Application for a Certificate of Appropriateness Date: July 9, 2014

LOCAL HISTORIC DISTRICT:	Plaza Midwood
PROPERTY ADDRESS:	1400 Pecan Avenue
SUMMARY OF REQUEST:	Chimney Removal
OWNER:	Brian Woods
APPLICANT:	Ryan DeRuby

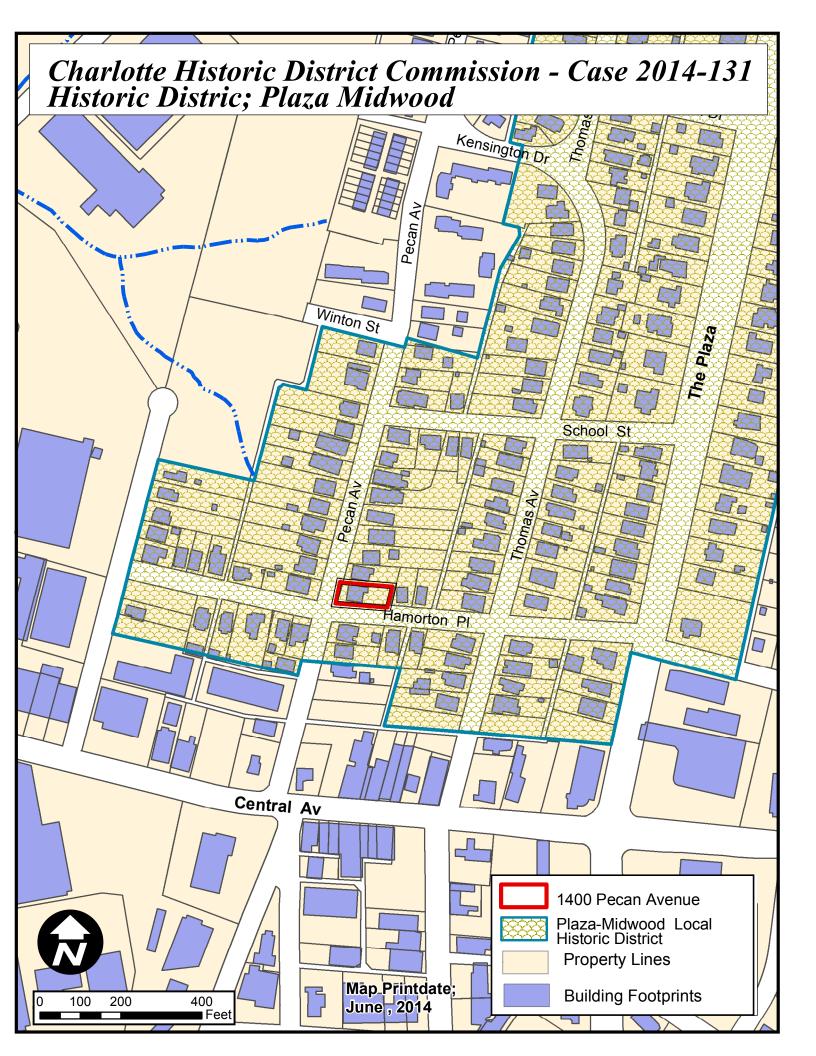
The Commission will determine if the removal of one chimney negatively impacts the character of the streetscape.
